SP VIANI P.E.
2014 Equestrian Way
Pilot Hill, CA 95664
Phone: 916-952-8503
spviani@aol.com

RE: Appeal of CEQA Revised Final Mitigated Negative Declaration

San Francisco City and County (CCSF) Planning Case No. 2013.1383ENV
Building Permit Application Nos. 2013.12.16.4318 and 2013.12.16.4322
3516 and 3526 Folsom Street

EVACUATION ROUTES

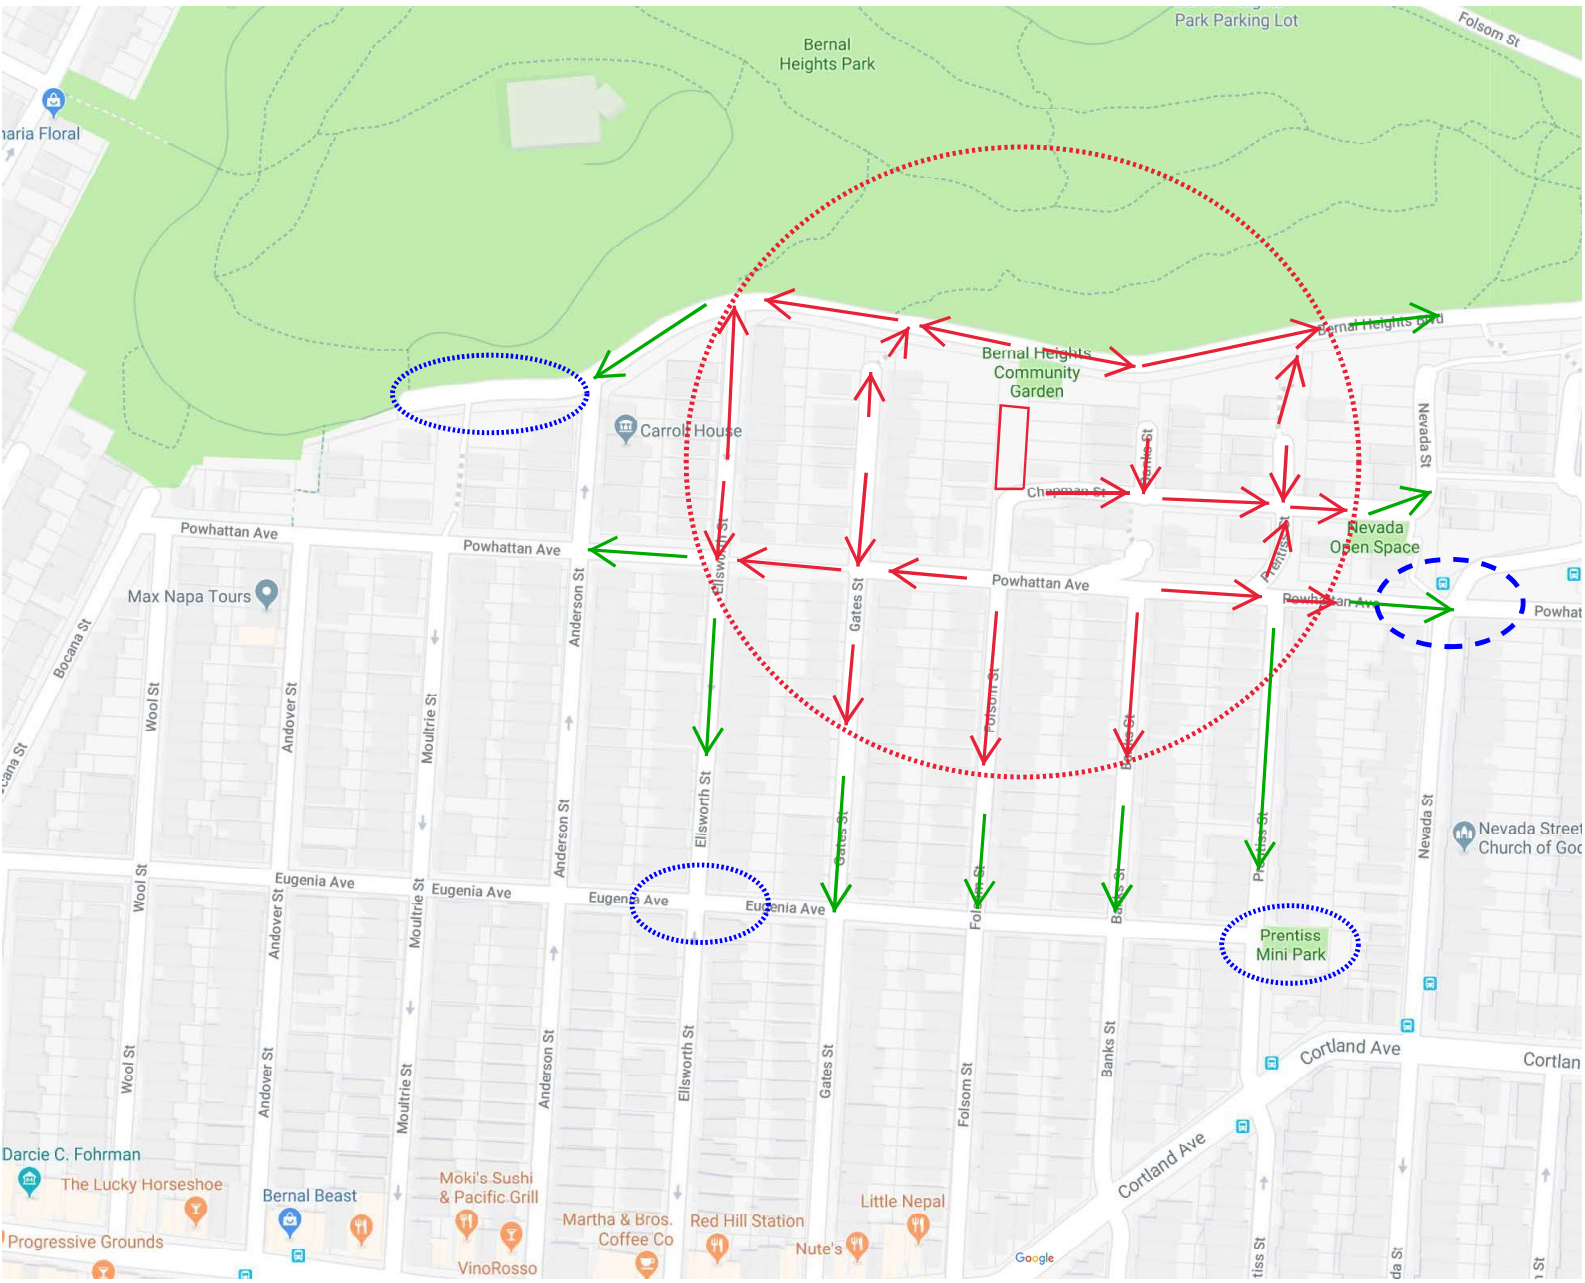
- The evacuation route consists of arrows - drawn by the Project Sponsor, not the Fire Department or Dept. of Emergency Management - on a downloaded Google map to be posted around the neighborhood. To us, this attached map represents mass confusion as the arrows show incorrect evacuation routes- According to (Pipeline Association for Public Awareness) PAPA guidelines, during a major gas leak it is critical not to evacuate downhill - gas migrates and collects downhill; and, not to evacuate downwind - gas travels with the wind. This was not taken into account.

- The plan includes a dangerously long 3-hour PG&E response time to a suspected leak. A lot can happen in 3 hours.
- The plan's 300-foot radius of evacuation area map is incorrect. The recommended minimum evacuation distance is 547' for a gas pipeline with a 100 psig for a 24" diameter pipeline, according to a table in PIPA's,
